ITEM FOR ENVIRONMENTAL COMMISSION AGENDA

NAME & NUMBER OF PROJECT: Estancia Phase 11 Condos
SP-2023-0032C

REQUEST: Variance request is as follows:
Request to vary from LDC 25-8-341 to allow cut greater than 4 feet on slopes greater than 15% and from LDC 25-8-342 to allow fill greater than 4 feet on slopes greater than 15% in the desired development zone.

Cut/Fill & Slopes Exhibit

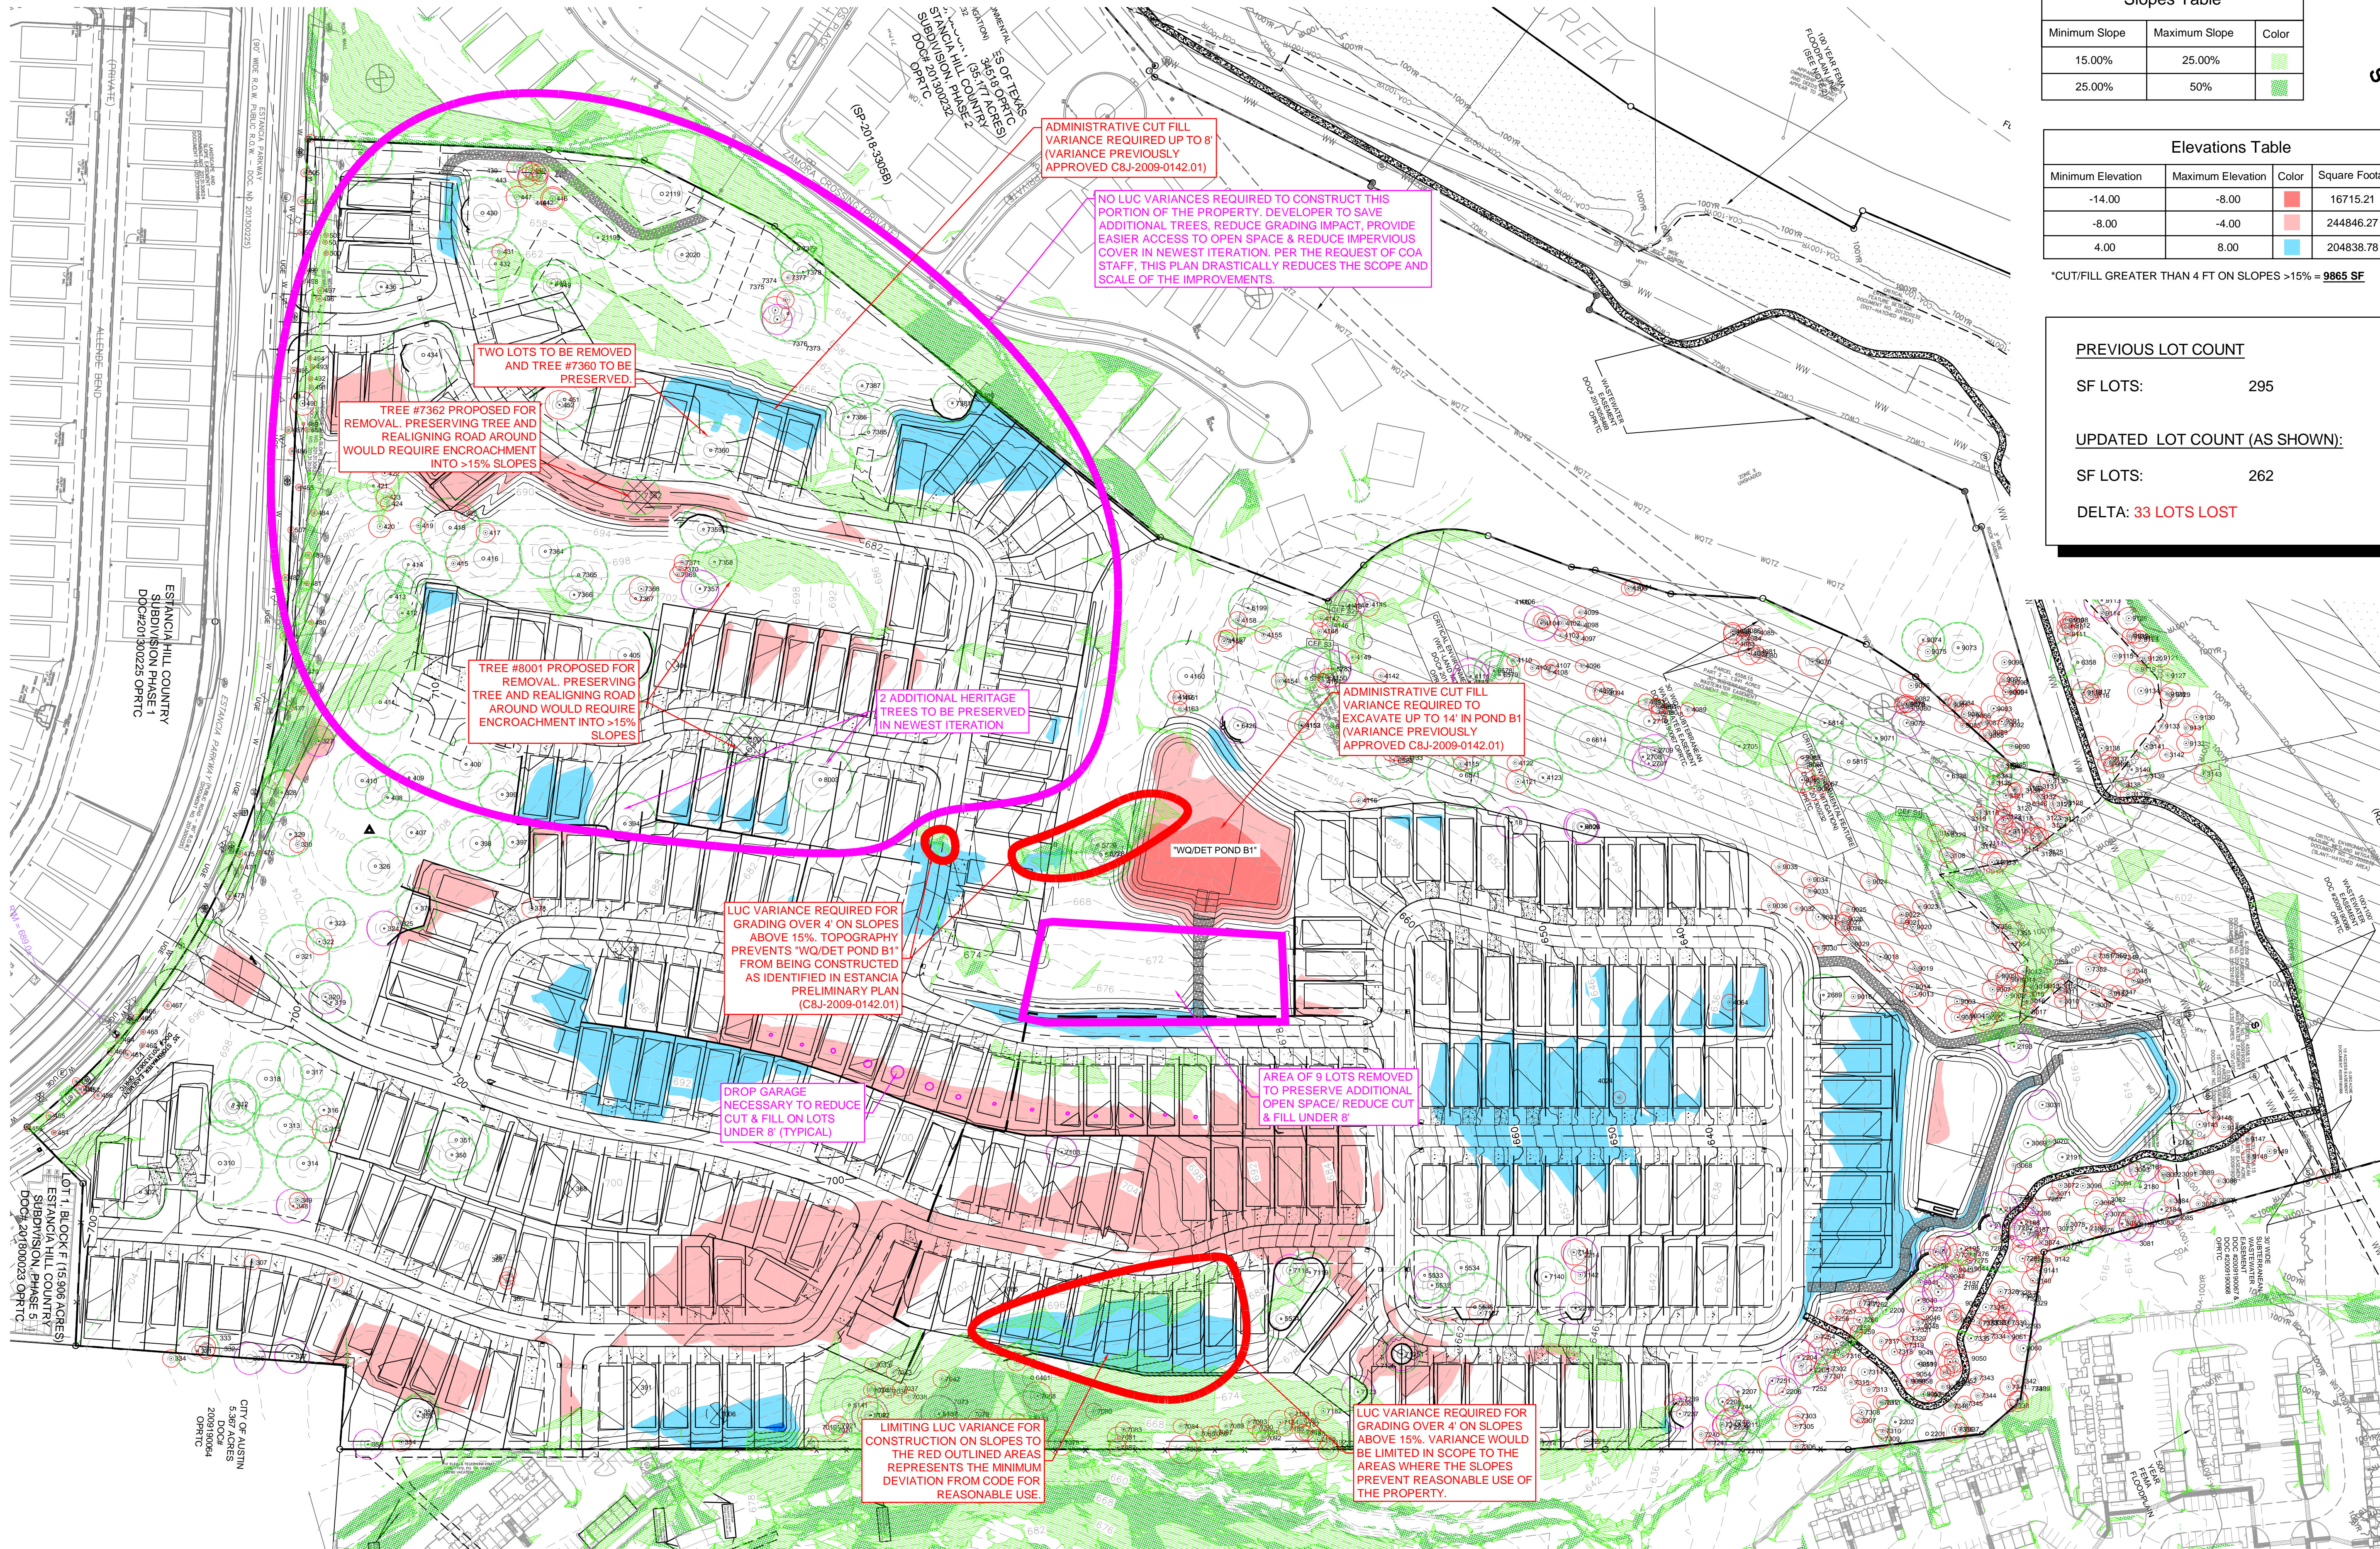
Project Name:	Estancia Phase 11 Condos
Ordinance Standard:	Watershed Protection Ordinance
Variance Request:	Request to vary from LDC 25-8-341 to allow cut from 4 to 8 feet on slopes greater than 15% and from LDC 25-8-342 to allow fill from 4 to 8 feet on slopes greater than 15% in the desired development zone.

Yes / No The method to develop the property is a typical method used on properties throughout the City and on the properties adjacent to this project. The current design proposal may provide greater overall environmental protection than is achievable without this variance by installing 2 biofiltration ponds, 50% more trees than required by landscape code, and a retaining wall, 609S native seeding/planting, and erosion matting in the area of steep slopes behind lots.

Yes / No The regulatory history of this property should be noted. The Estancia Hill Country PUD as well as Preliminary Plan C8J-2009-0142.01 both adjust code to allow for increased grading and increased development on steeper slopes. The preliminary plan allows for grading up to 14 feet for pond construction and grading up to 8 feet throughout. The PUD stipulates that parking, driveways, and ROWs may be constructed on slopes up to 25%. However, the code adjustments do not specifically address grading which occurs on steep slopes. These grading scenarios are as follows: 1) To construct the project with the pond locations agreed upon in the preliminary plan, some grading over 4 feet on slopes over 15% is required. 2) A portion of the scope of this variance request is to construct a driveway on slopes greater than 15% utilizing a small amount of grading over 4 feet. Efforts have been taken to realign the roadways in order to avoid this situation to the extent practicable. 3) The rest of the grading over 4 feet which is also on slopes greater than 15% is to allow for the construction of ~6 condo units.

The only grading greater than 8 feet is to construct the pond in order to contain the necessary stormwater volume.

Clearly indicate in what way the proposed project does not comply with current Code (include maps and exhibits)	This project is proposing cut over 4 feet on 15% slopes and fill over 4 feet on 15% slopes.
---	---

STAFF RECOMMENDATION: Staff recommends this variance, having determined the findings of fact to have been met.

- 1) Ponds onsite will be biofiltration ponds
- 2) Plant 50% more trees than required by landscape code
- 3) Retaining wall, 609S seeding/planting, and erosion matting in areas of grading on steep slopes behind lots
